CERTIFICATE OF APPROPRIATENESS

Property: 321 Heights Boulevard, Lot 4 and Tract 5, Block 313, Houston Heights Subdivision. The property includes a historic 2,751 square foot two-story wood frame single-family residence situated on a 14,950 square foot corner lot. The existing house is located on Lot 5 and the owner is proposing to build a second structure at the rear of Tract 4.

Proposal: New Construction – Construct a two-story 2,536 square foot residence and garage.

EAST ELEVATION – FRONT FACING HEIGHTS BOULEVARD
PROPOSED

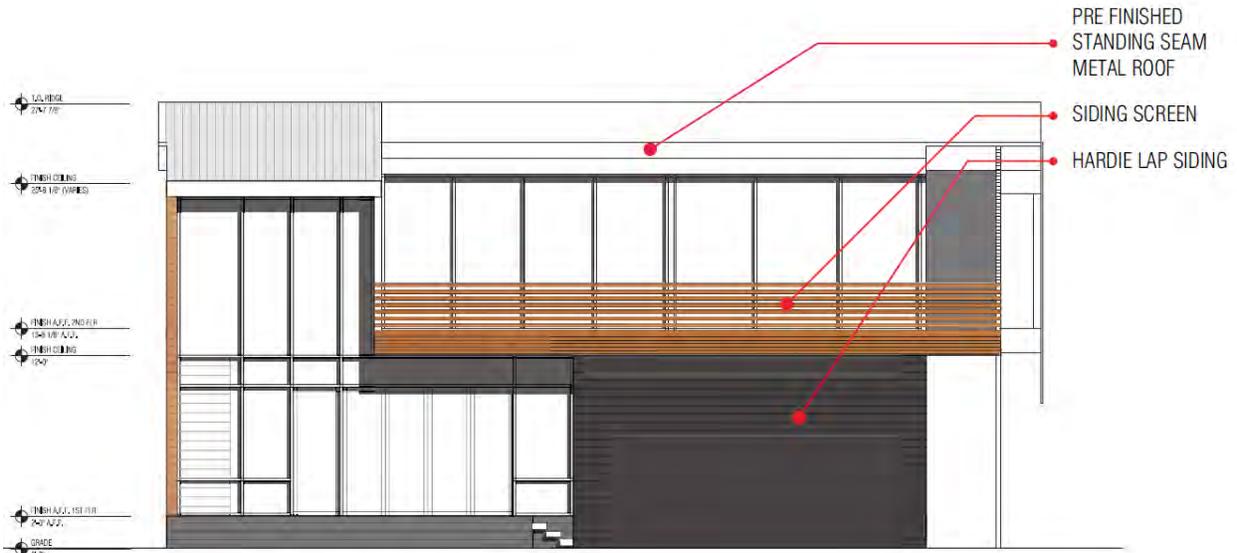
The lack of fenestration on the façade and low roof pitch of the proposed new residence and garage is not compatible with the existing contributing structures within the Houston Heights Historic District South. Additional fenestration and a more traditional roof pitch should be incorporated.
- (3) The proportions of the new construction, including width and roofline, must be compatible with the typical proportions of existing contributing structures and objects in the historic district

The 42' width of the proposed structure is wider than what is typically found in the Houston Heights Historic District South. A more compatible width would not typically exceed 35'. The proposed roofline does not match typical district roofline configurations. The proposed roof has a pitch of 2" per 12", with more typical roofs having steeper pitches. More compatible roofs would feature pitches ranging from 5:12 - 8:12.
- (4) The height of the eaves of a new construction intended for use for residential purposes must not be taller than the typical height of the eaves of existing contributing structures used for residential purposes in the historic district; and

The proposed eave height 26.5' is significantly higher for that of a typical contributing house within the Houston Heights Historic District South. A more compatible eave height for a house would be around 20' and typically lower for a secondary structure.
- (5) The height of new construction intended for use for commercial purposes must not be taller than the typical height of the existing structures used for commercial purposes in the historic district.
